Docket Item # 2
BAR CASE # 2015-0180

BAR Meeting
July 1, 2015

ISSUE: Historic Warehouse
APPLICANT: RTS Associates, LLC
LOCATION: 2 Duke Street
ZONE: W-1 / Waterfront

BAR2015-00180

NO. 2 DUKE - CANOPY / OTHER DETAILS

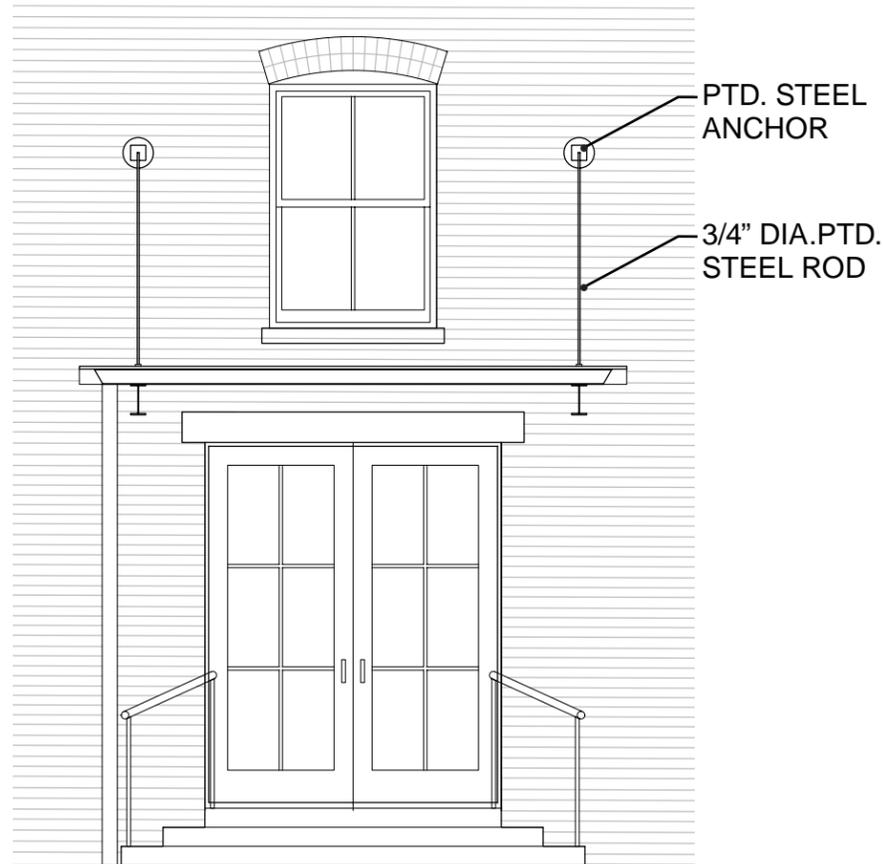
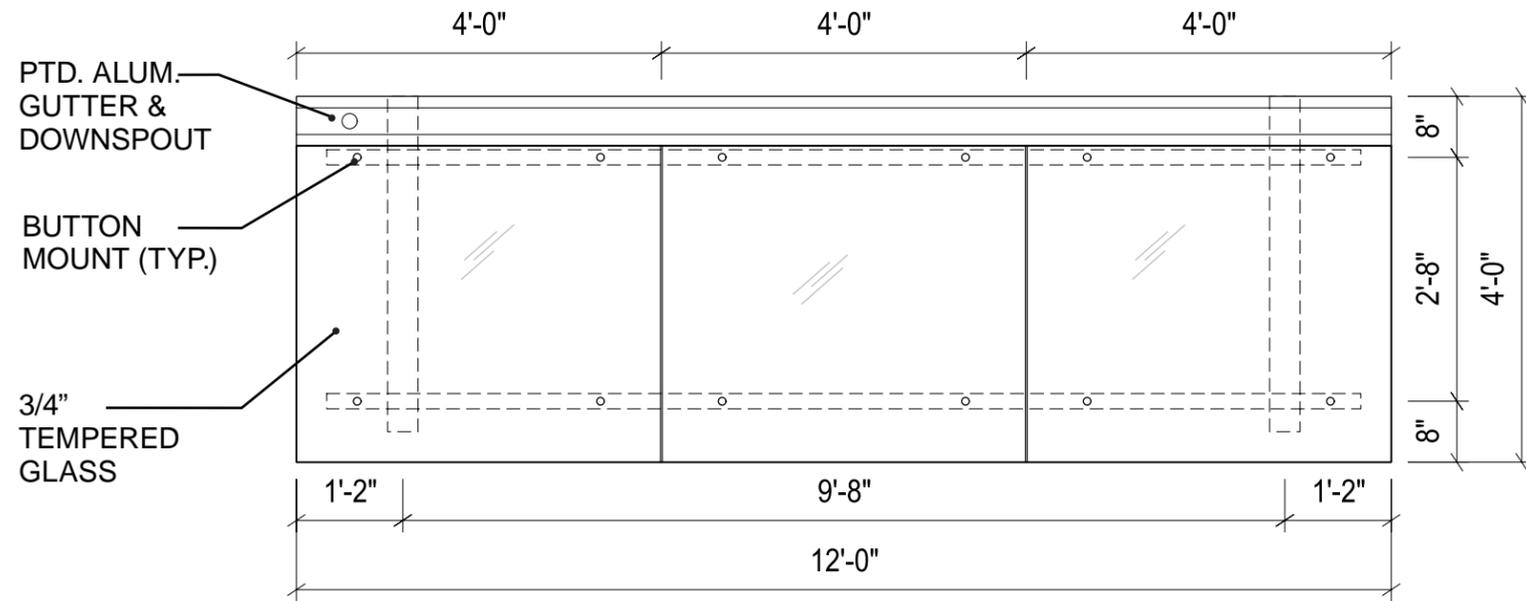
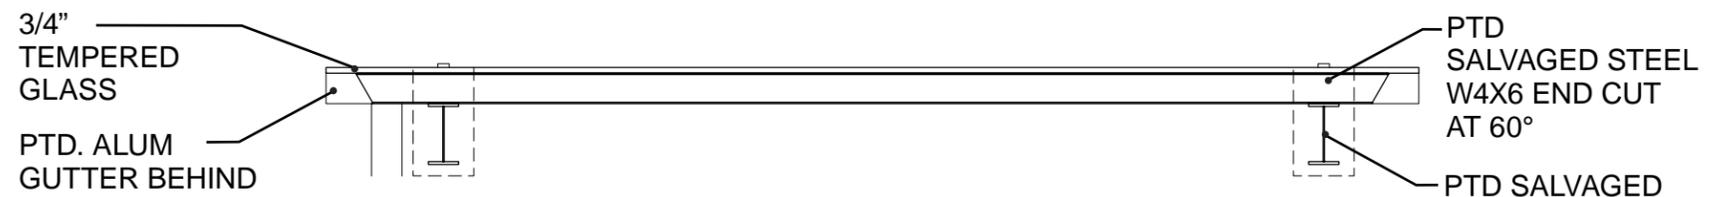
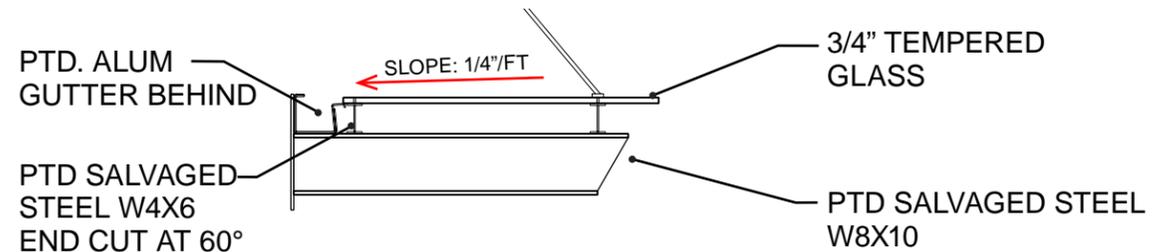
At the previous concept reviews, some BAR members opposed a suspended projecting canopy over the entrance. The applicant still proposes such a canopy but has presented a more refined and visually light canopy than the previous design. The canopies are proposed for both the north and south entrances to the building. The applicant has stated in discussions with staff that they believe that canopies are needed to help identify the entrances, provide weather protection above the entry doors and steps, and to enhance this space for retail use by further differentiating this building from the future residential townhouses that will be located immediately to the west. The proposed canopies are a contemporary glass and steel design that recall the suspended metal canopies common to this type warehouse and are easily removable if desired in the future. Therefore, staff finds that the refined and more delicate canopies proposed are appropriate when considered in respect to the overall site arrangement and mix of residential and commercial uses here.

WINDOW DETAILS

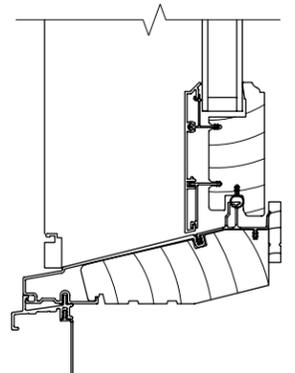
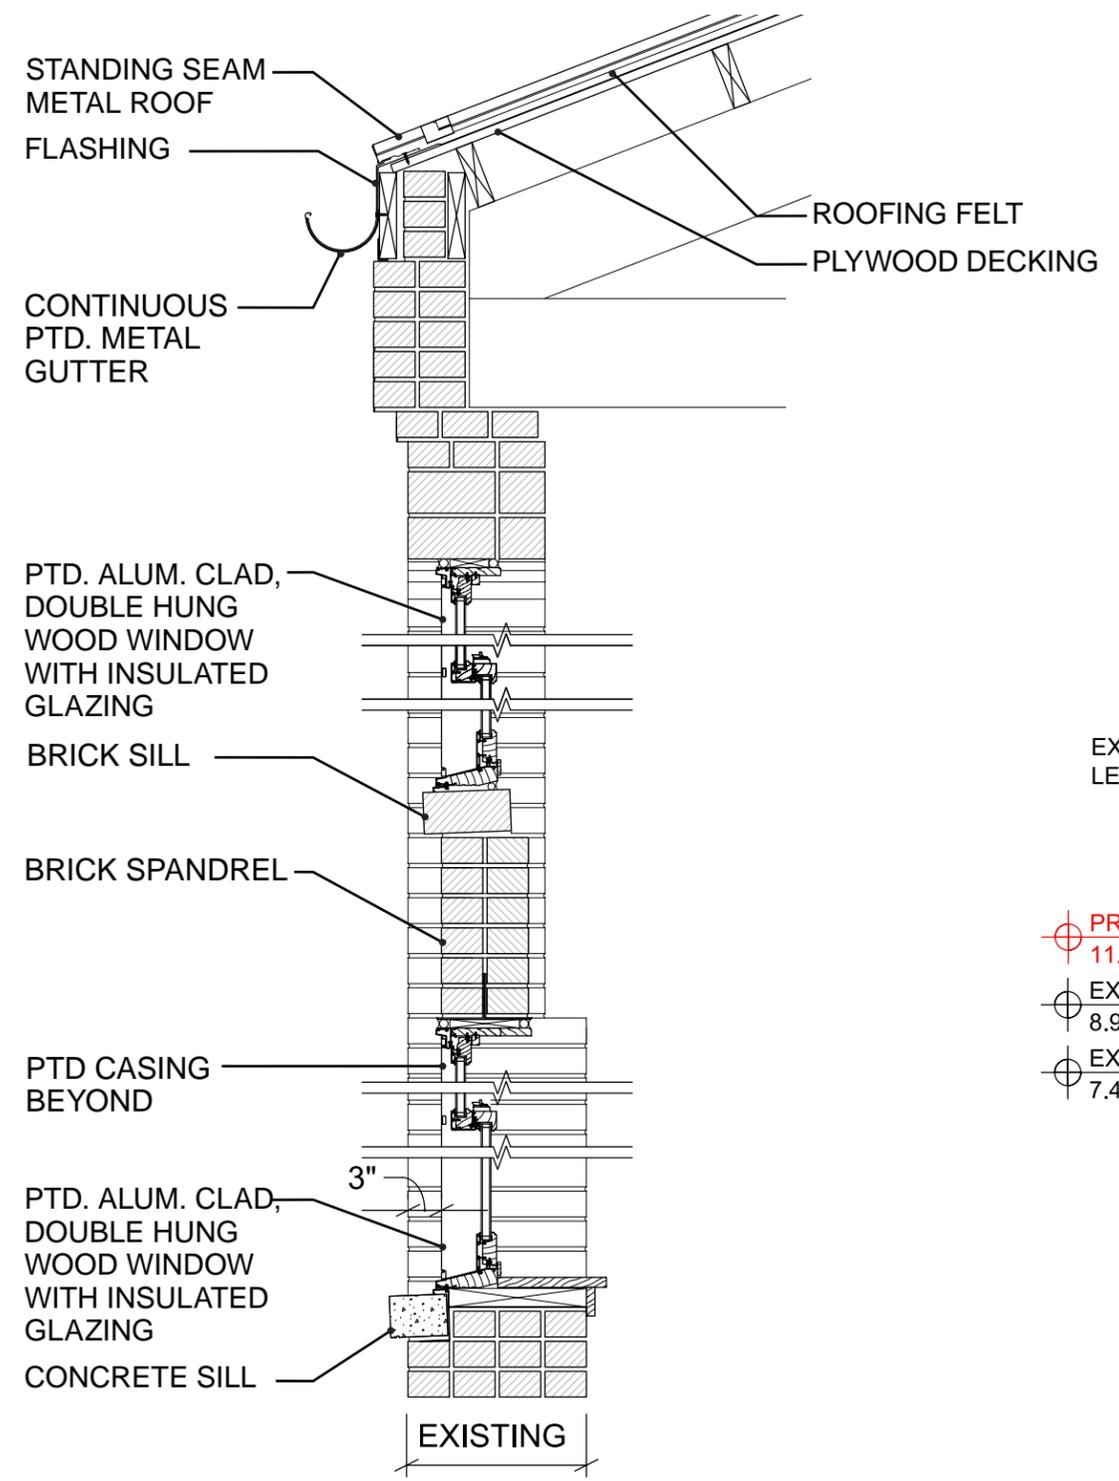
The applicant has proposed a high quality aluminum clad wood window that meets the BAR's performance specifications for buildings constructed after 1965. However, under *the BAR Window Policy*, painted wood windows would be most appropriate and the only window type that staff could administratively approve for this early building. Although all of the window openings have been altered and no original windows remain, and with the understanding that this is an adaptive use of a utilitarian warehouse and not a museum restoration, staff still finds that a painted wood window would be more historically appropriate to represent the building's original date of construction, particularly once it is surrounded by new construction. Therefore, staff recommends that the BAR approve painted wood windows, consistent with the approved policy for all early residential and commercial buildings.

1. That the roof truss system be retained *in situ*.
2. That the applicant work with staff for final approval of historically appropriate mortar and brick infill where necessary.
3. That the applicant work closely with staff in the field when removing the existing non-historic façade to ensure that historic fabric that may not currently be known or visible is not lost during the rehabilitation.
4. That the applicant submit window specifications for painted wood windows that are in conformance with the BAR's adopted Performance Specifications, for final approval by staff.
